CBD & South-East Light Rail Project

Submission on CBD & South-East Light Rail Project

Submitted to NSW Department of Planning & Infrastructure
On Behalf of University of NSW

16 December 2013 ■ 13533

Figure 16 – UNSW Anzac Parade Stop – All Aspects

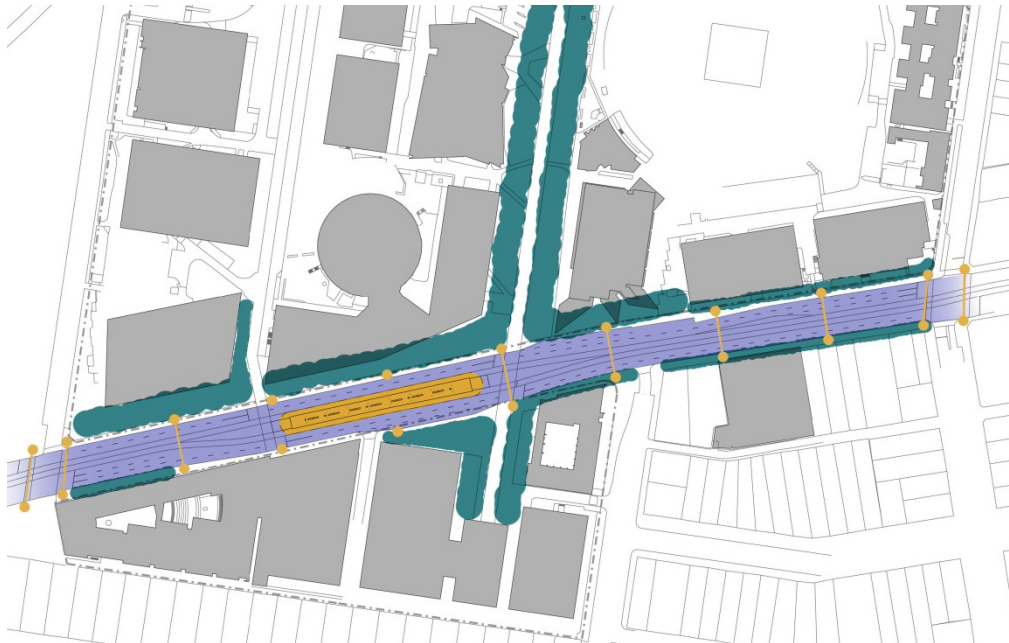
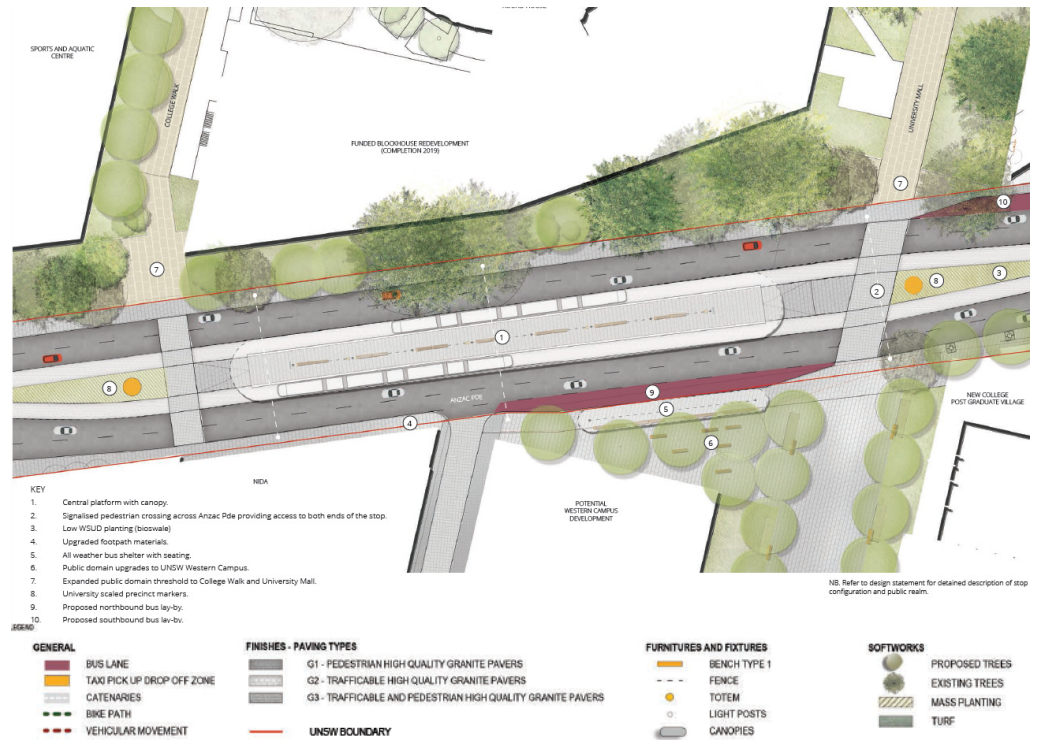
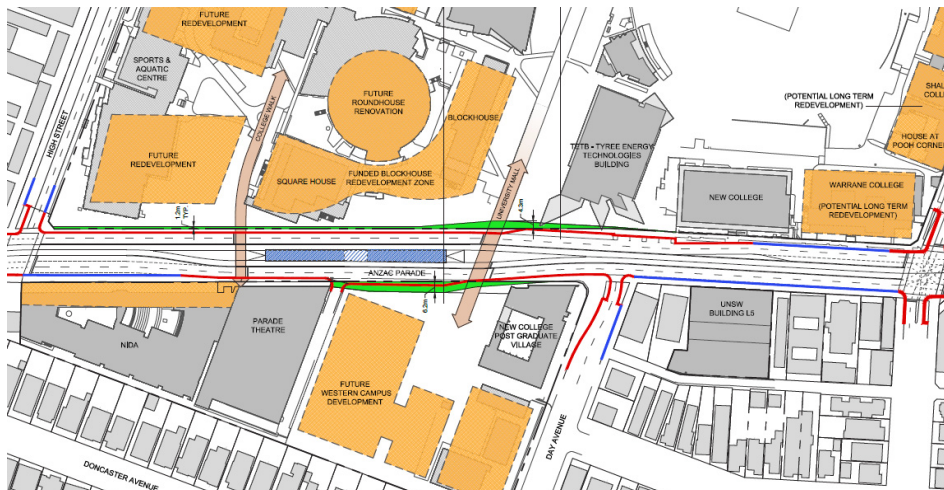
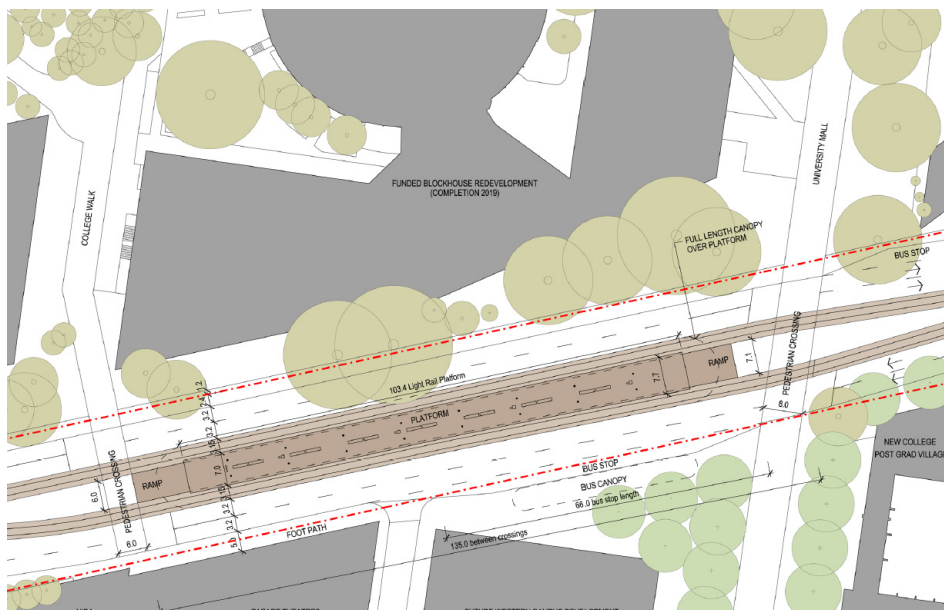
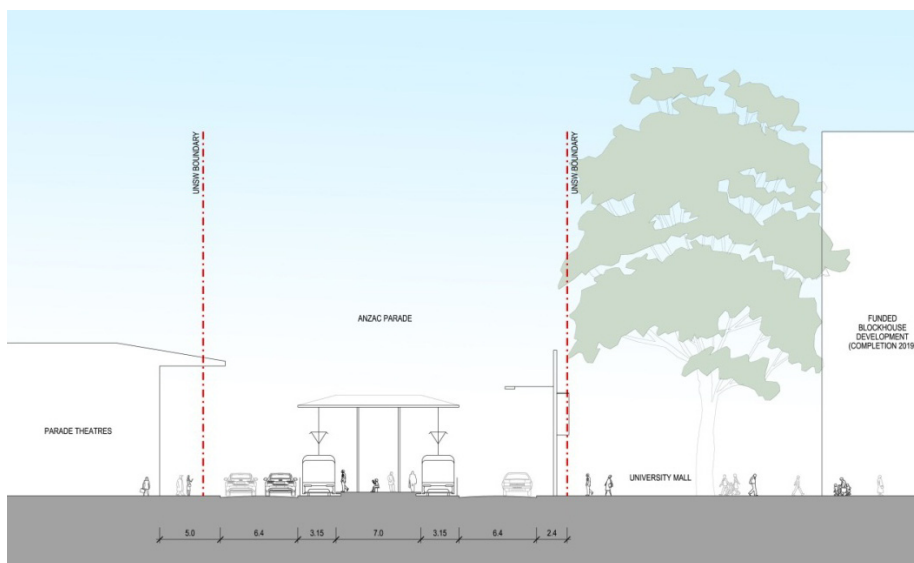
- Centrally aligned tracks and platform;
- 103.4m long, 6.6 to 7.7m wide platform, double loaded from either end providing a ~730m² platform (refer **Appendix A**, Drawing 22);

- Double pedestrian crossing points (8m wide and 6m wide) leading directly into UNSW at University Mall and College Walk, respectively, and NIDA on western edge of Anzac Parade (refer **Appendix A**, Drawing 18);

- Canopy or shelter over 100% of the platform (refer **Appendix A**, Drawing 24);
- CCTV, ticketing and information;
- Retains and increases existing width of trafficable lanes on Anzac Parade at/to 3.2m for kerbside lanes and 3.5m for centre lanes (refer **Appendix A**, Drawing 23);

- Use of the “Boulevard character” to reflect the nature of Anzac Parade, the significant mall entry and gateway to UNSW and the wider Education & Health Specialised Centre; and
- Adjacent improvements to cater for bus stops both south and north-bound and new taxi stands (refer **Appendix A**, Drawing 20).

Given the expected level of use of College Walk and its location at an appropriate distance between University Mall and High Street, a signalised pedestrian crossing of Anzac Parade where College Walk intersects is essential to provide safe and easy access to the Anzac Parade stop. The crossing is planned to be 6 metres wide providing an appropriately proportionate width in relation to the University Mall crossing.

Figure 24 – UNSW High Street Stop – Design Concept Rendering

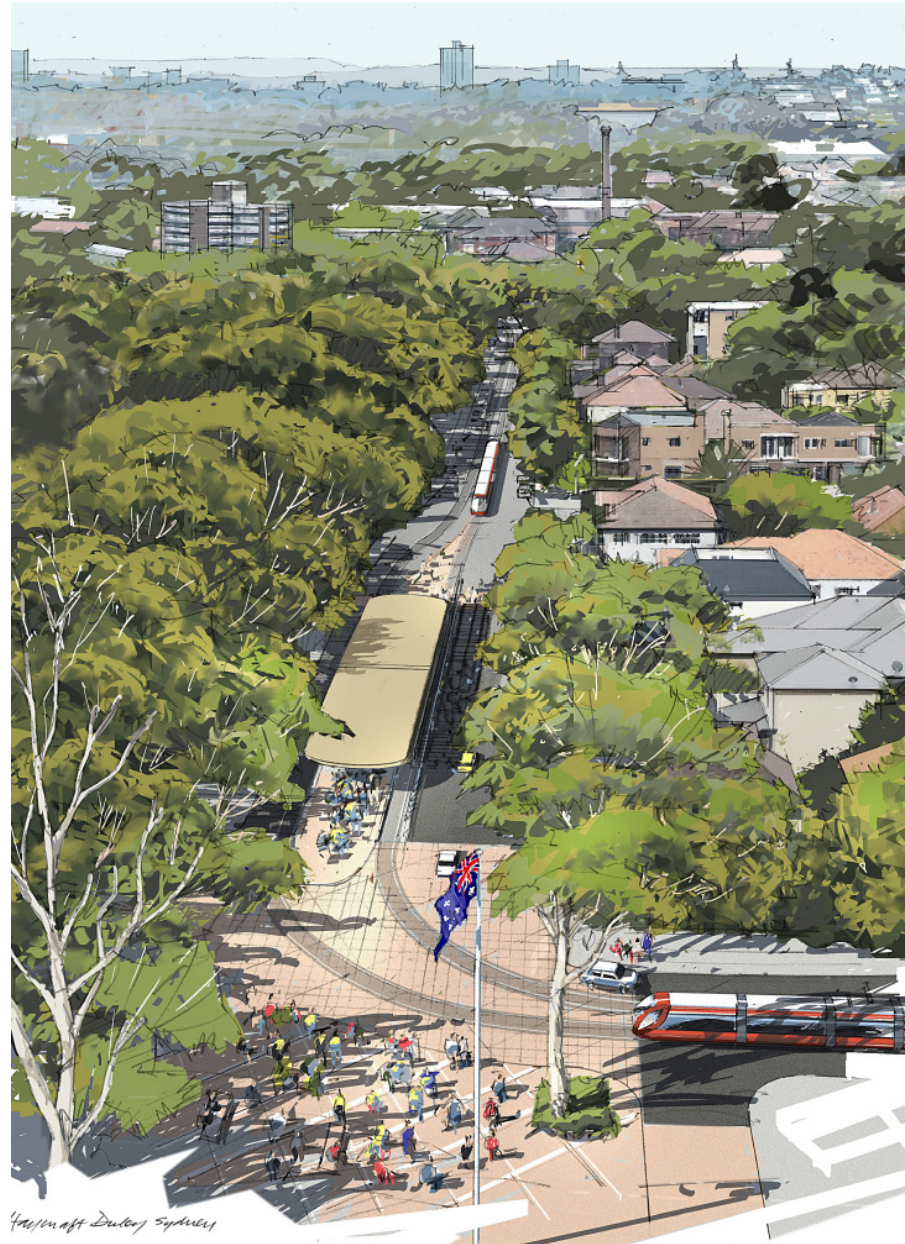
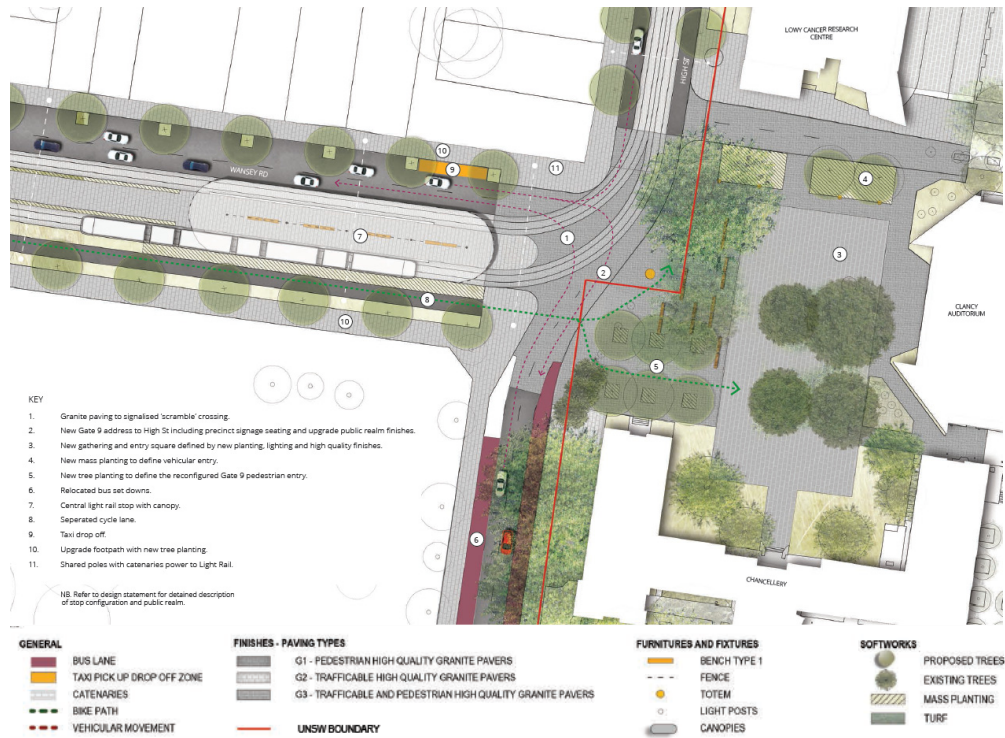
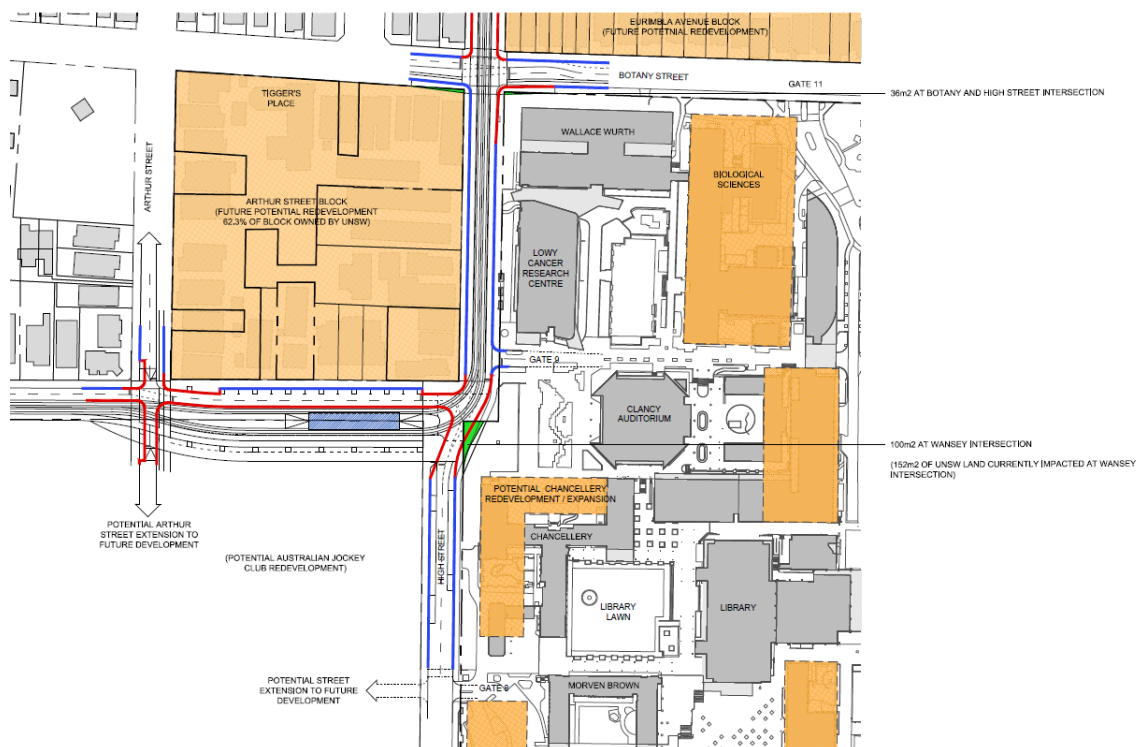
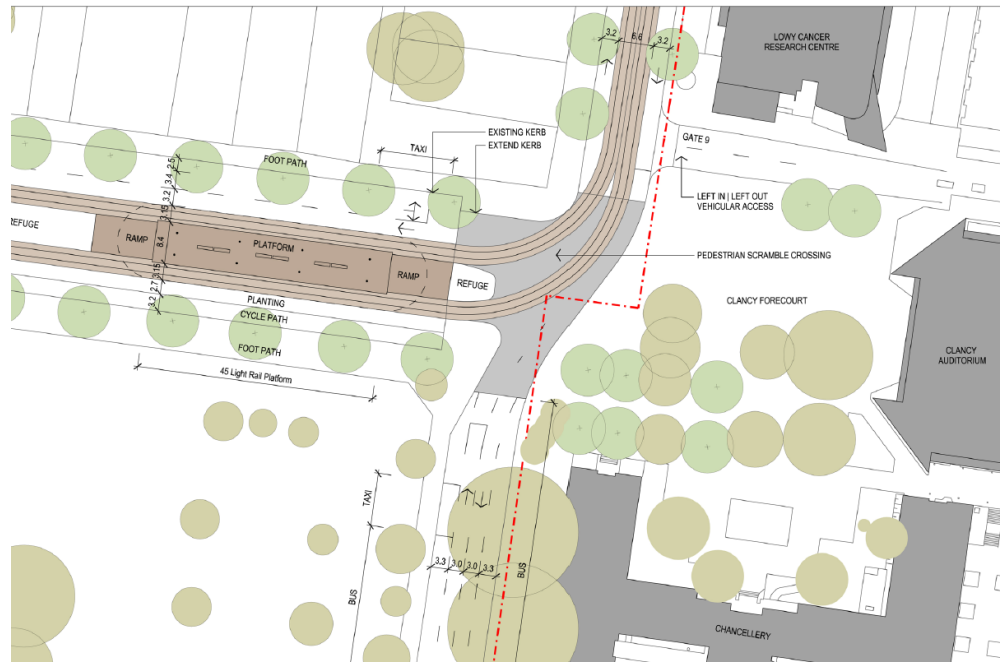
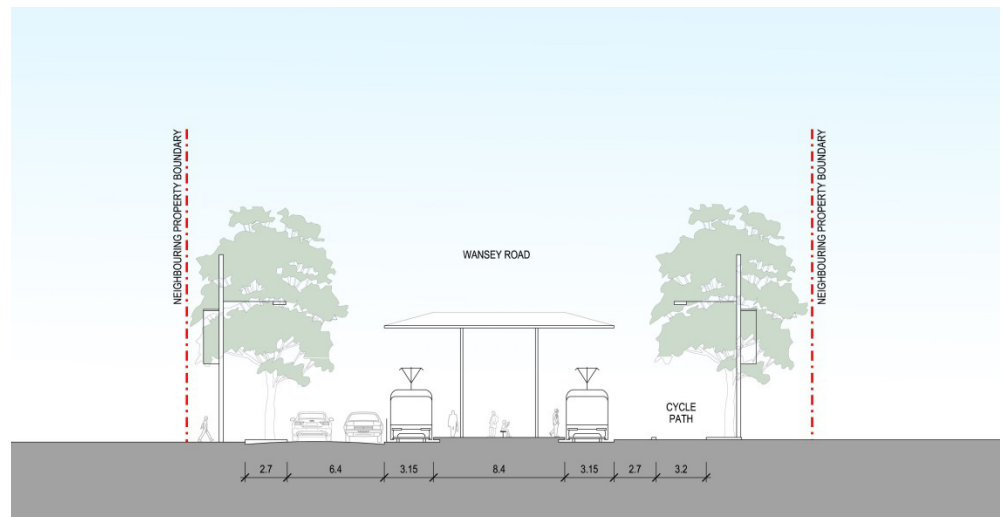
- Centrally aligned tracks and platform;
- 45m long, up to 8.4m wide platform providing a 360m² platform (refer **Appendix A**, Drawing 36);

- A scramble crossing at High Street / Wansey Road intersection, with unique paving treatment to reflect nature of crossing (refer **Appendix A**, Drawing 32);

- Canopy or shelter over 100% of the platform (refer **Appendix A**, Drawing 38);
- CCTV, ticketing and information;
- Removal or reduction in clutter through undergrounding of cables or use of joint-use poles (refer **Appendix A**, Drawing 33);

- No right turn into Wansey from High Street in westerly direction. Left in and left out of Wansey Road, which is retained as a two-way carriageway of 3.4m wide southbound lane and 3.2m wide northbound lane (refer **Appendix A**, Drawing 37);

- Left in and Left out traffic at Gate 9;
- Relocated bus stops to outside Gate 8 on High Street for both east and westbound routes arriving and departing UNSW (refer **Appendix A**, Drawing 34);

As in Anzac Parade a centre platform is the safer typology. The expected patronage of the stop is high and will require a 45 m long and 8.4m wide platform with full canopy cover high and wide to match the Anzac Parade stop. To the east of the platform is one traffic lane in each direction and a south bound parking lane that contains new tree planting and beyond this an upgraded footpath.

Figures 32 and 33 below show UNSW's utilities and services in relation to Anzac Parade and High Street. These are also located at Drawings 44 and 46 at **Appendix A**.

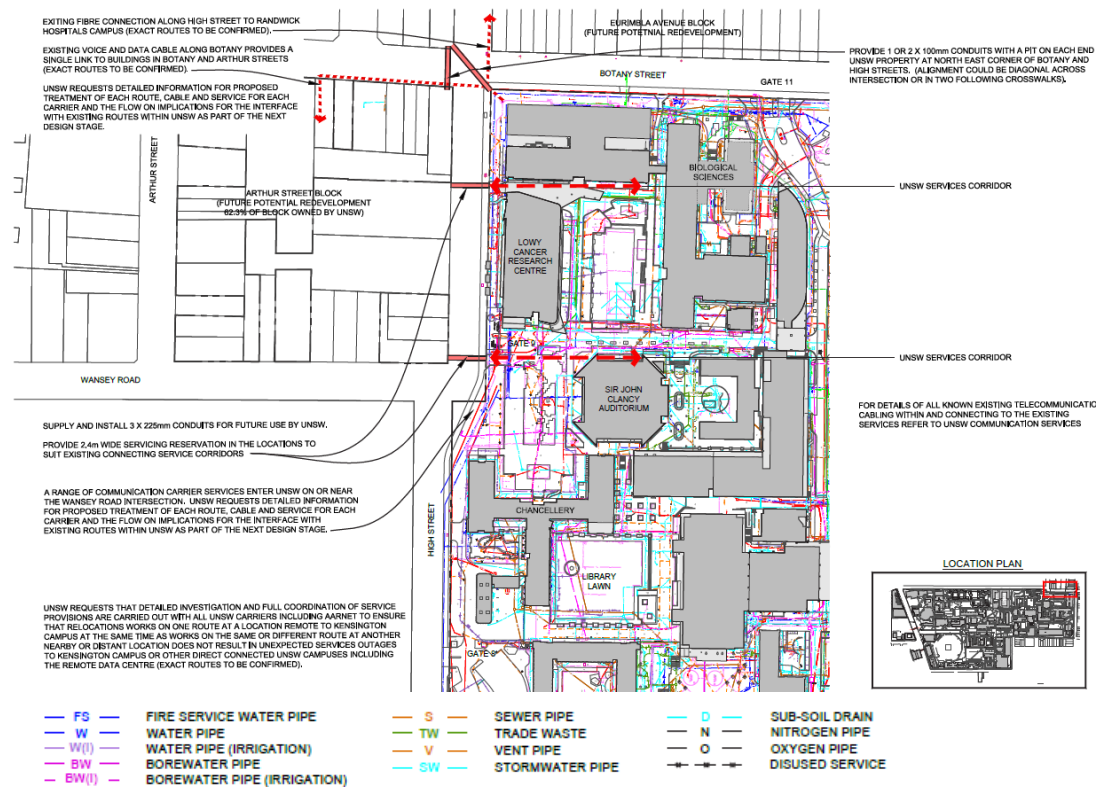
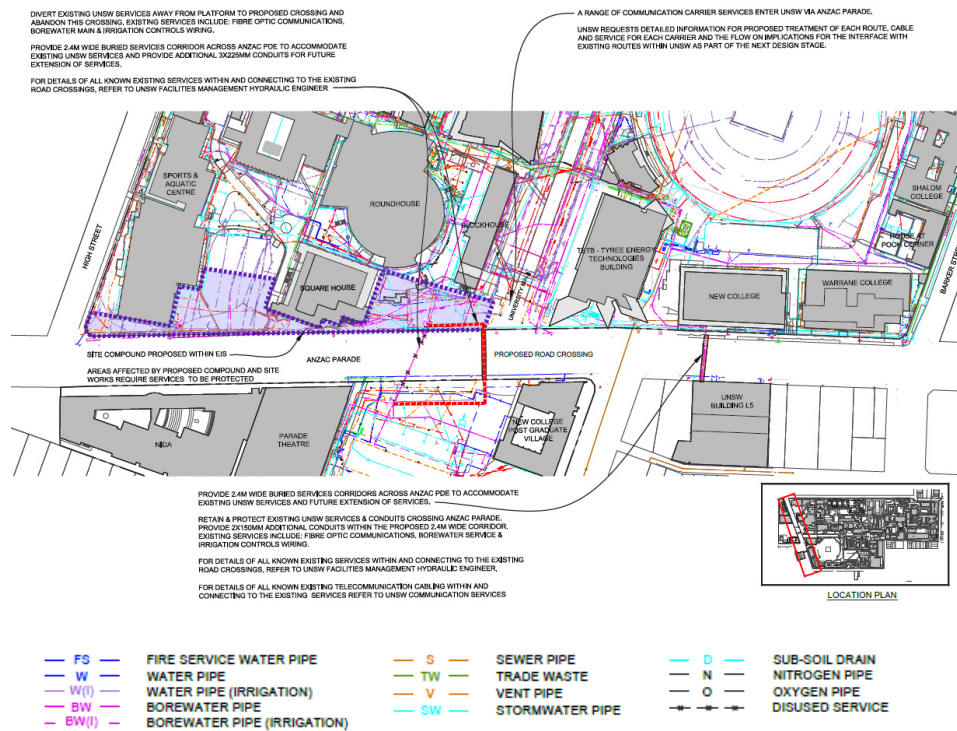
- Location of two of the three large water production bores and associated services for the city of Kensington Campus which draws some 200kL / day of groundwater for 'commercial' uses,
- UNSW main stormwater pipeline runs within part of this strip of land,
- Bore water reticulation drain point lies immediately beneath the platform.
- Irrigation pipelines that run the length of the proposed land acquisition.
- Trade waste grease arrester and associated sewer drainage.
- Bore water mains exist across Anzac Parade to provide supply to Western Campus and to L5 site.

The existing local stormwater flooding along Anzac Parade from High Street to Day Street adjacent to UNSW is not addressed. The UNSW overland stormwater flood path drains onto Anzac Parade across the proposed construction compound and the UNSW Anzac Parade stop. (refer to **Appendix A**, Drawing 45). It is noted that Randwick City Council have prepared the Kensington – Centennial Park Flood Study, Draft for Public Exhibition November 2012 indicating stormwater flooding issues that exist. The implementation of the CSELR Project is to take these matters into consideration to ensure that no deterioration of performance is experienced.

Currently, the EIS does not documentation does not include an existing conduit route across Anzac Parade to Western Campus on the relevant drawing. The conduit contains fibre and voice cables providing data & some voice services to National Institute of Dramatic Art and New College Postgraduate Village. It is the only route available and disruption will result in total loss of data service. It is therefore requested that the proposed treatment of this route is discussed in detail with UNSW Communications Services during the next stage of design.

Also, an area adjoining the south west corner of the UNSW Squarehouse building is included in the extent of the permanent works boundary. There are a communications services conduits running through the defined area. Routes included are the single lead-in voice and data route providing services to the Squarehouse as well as a cable route from Anzac Parade to the Blockhouse. It is requested that the proposed treatments in relation to these routes are discussed in detail with UNSW Communications Services and Facilities Management during the next stage of design.
